LBNF

Modification since V4

Ground Plane to DSS Interface

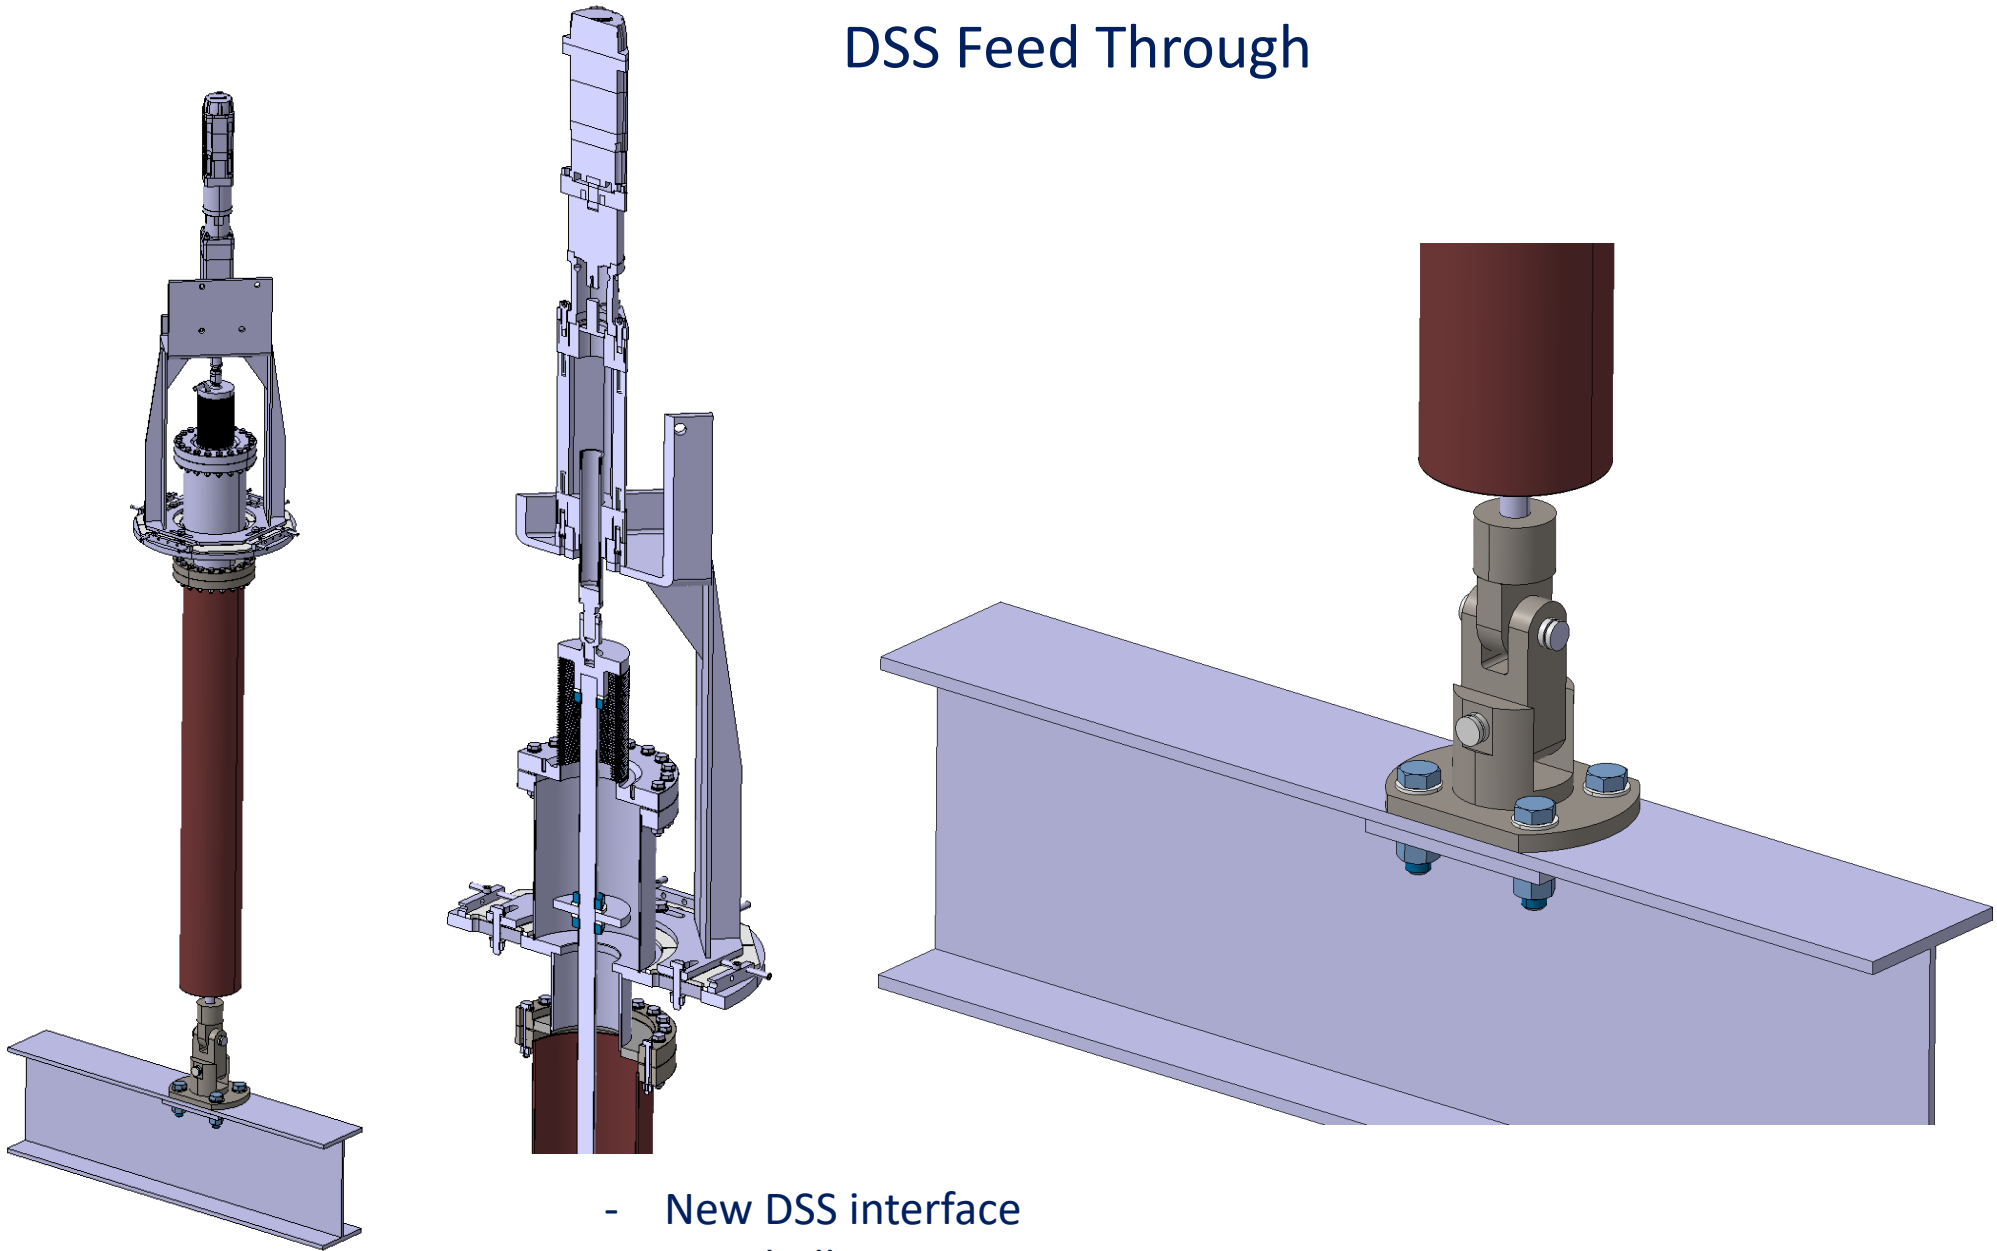
- New Ground Plane-to-DSS Rail interface & supports

DSS Feed Through

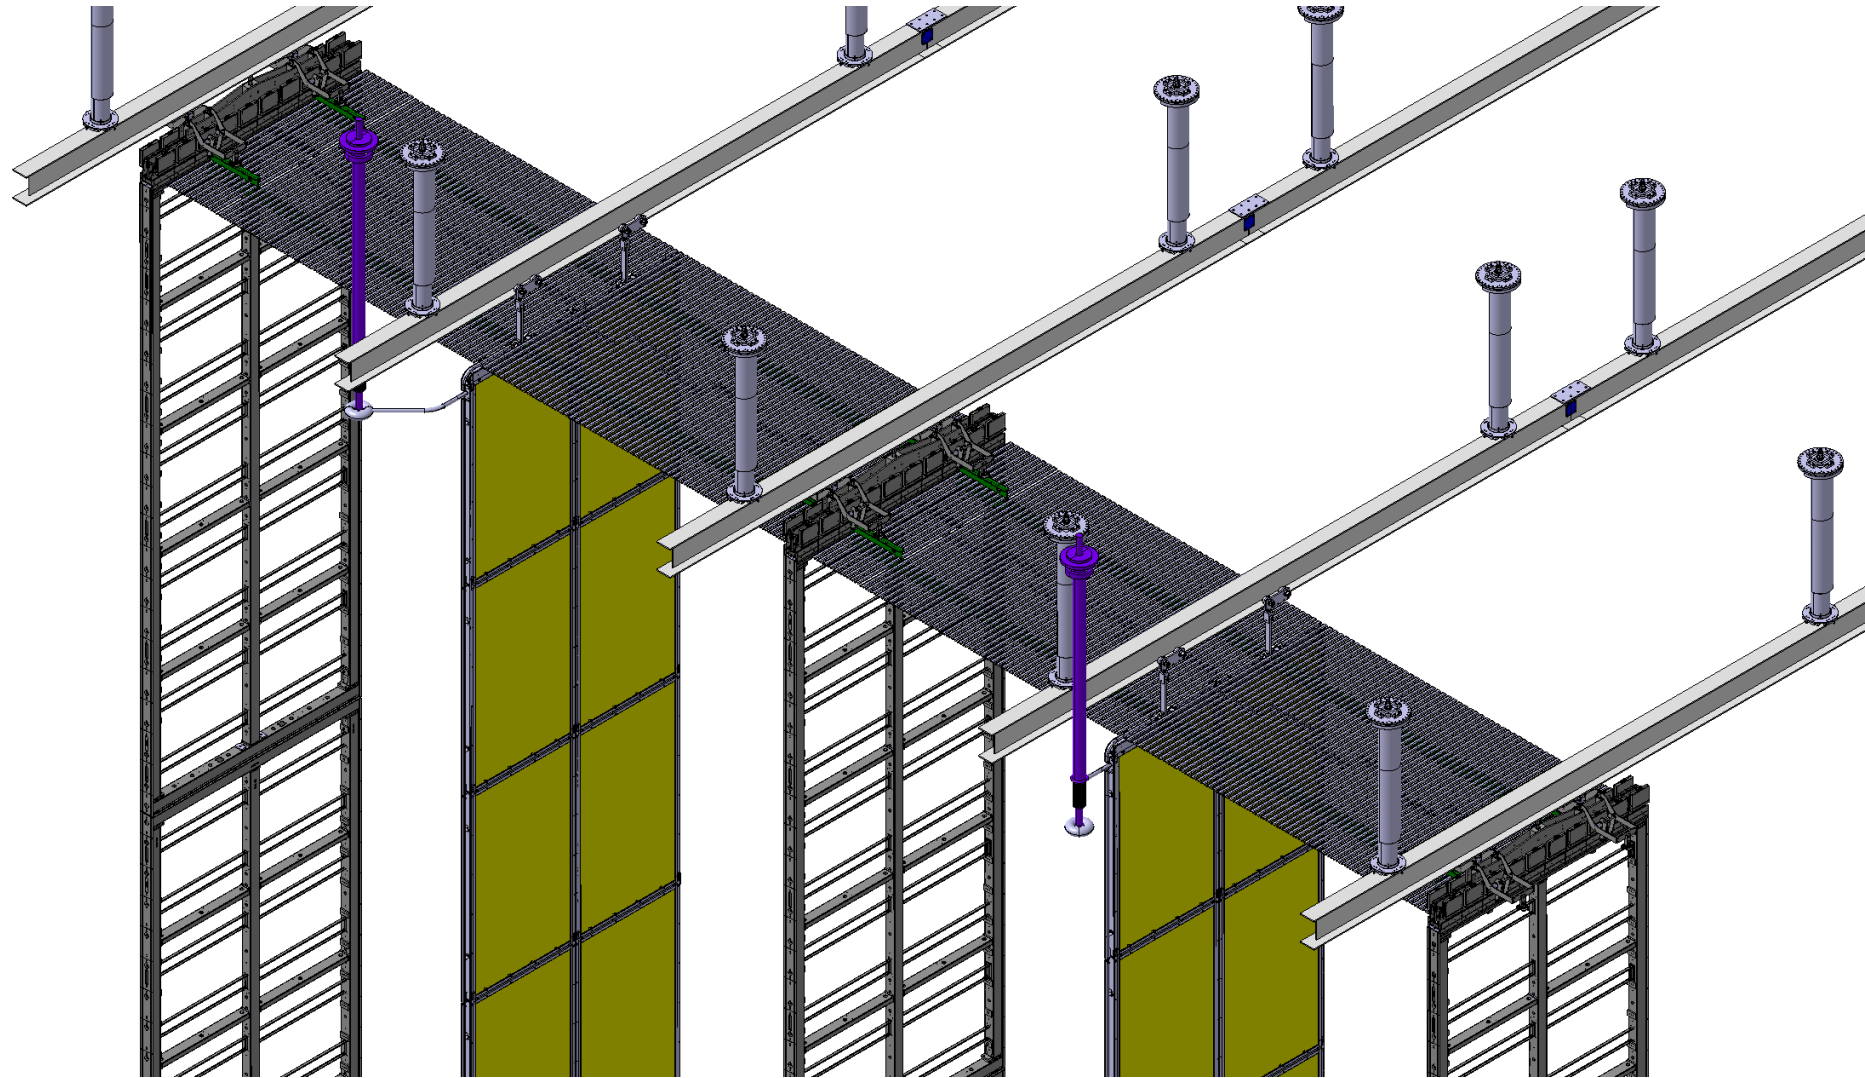
- New DSS interface
- New bellow arrangement
- Added possibility for motorised height advisement
